Office Action Summary	Application No. 10/605,781	Applicant(s) HOOKE, DAVID ANDREW	
	Examiner Nathan E. Durham	Art Unit 3765

DETAILED ACTION***Response to Amendment and Arguments***

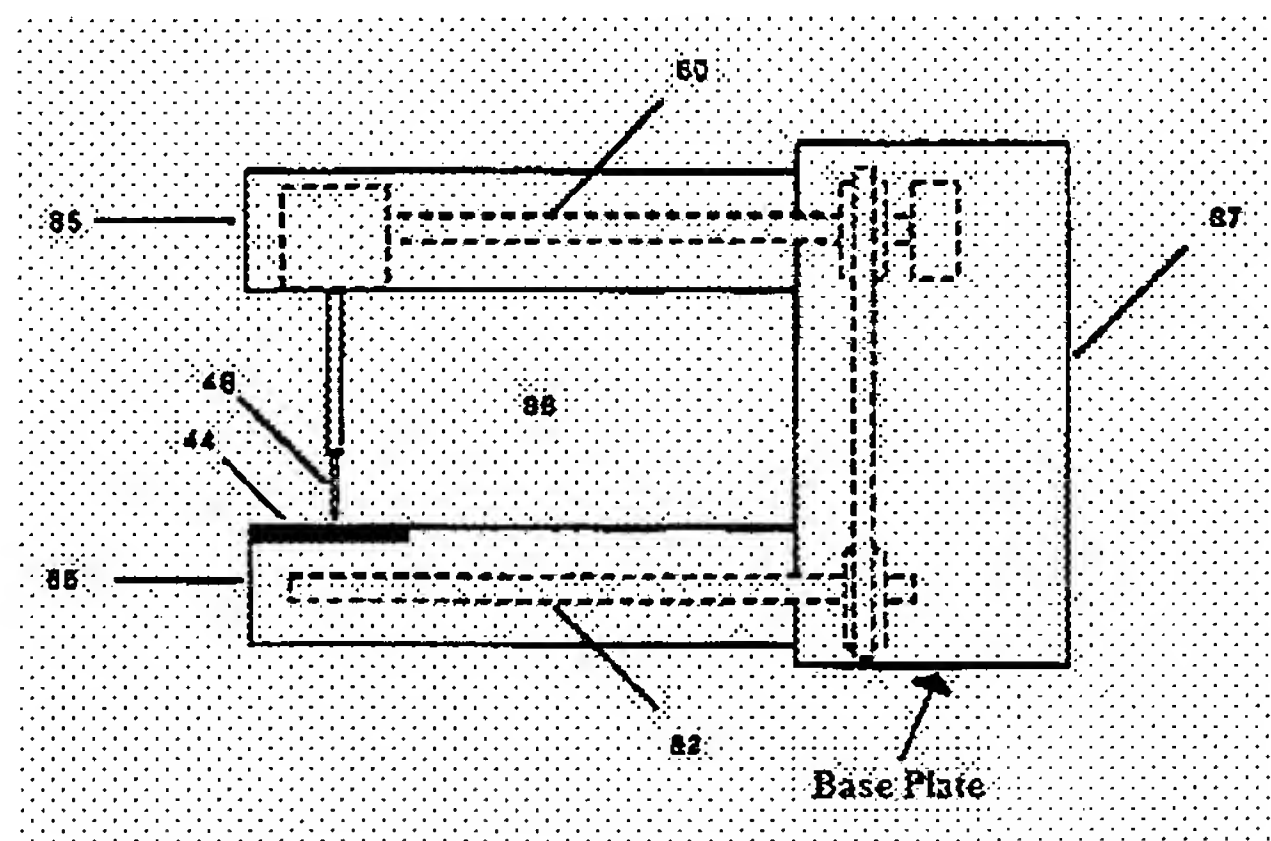
Regarding claims 1 and 4, KOERNER discloses an electronic stitch length regulator comprising a speed sensor (16, 64, 230, 266), a sensor arm (44, 86), a

base plate (Refer to figure below), an electronic circuit (18, 65, 65', 268) and an electrical output connector. In the first few embodiments of the invention it is inherently shown that an electrical output connector exists as represented by figures 1, 2 and 7. Some sort of connector is inherently needed between the output (i.e. electrical) of the circuit to the device that is to be controlled (i.e. needle actuator, clutch/brake assembly, motor drive) in order to transmit the electrical output signals to control the device. In the embodiment as represented by figure 16, the electrical output connector can be considered the foot control adapter (270), cable (272) and/or plug (272). KOERNER further discloses the base plate being mounted below the sewing machine (Refer to figure below).
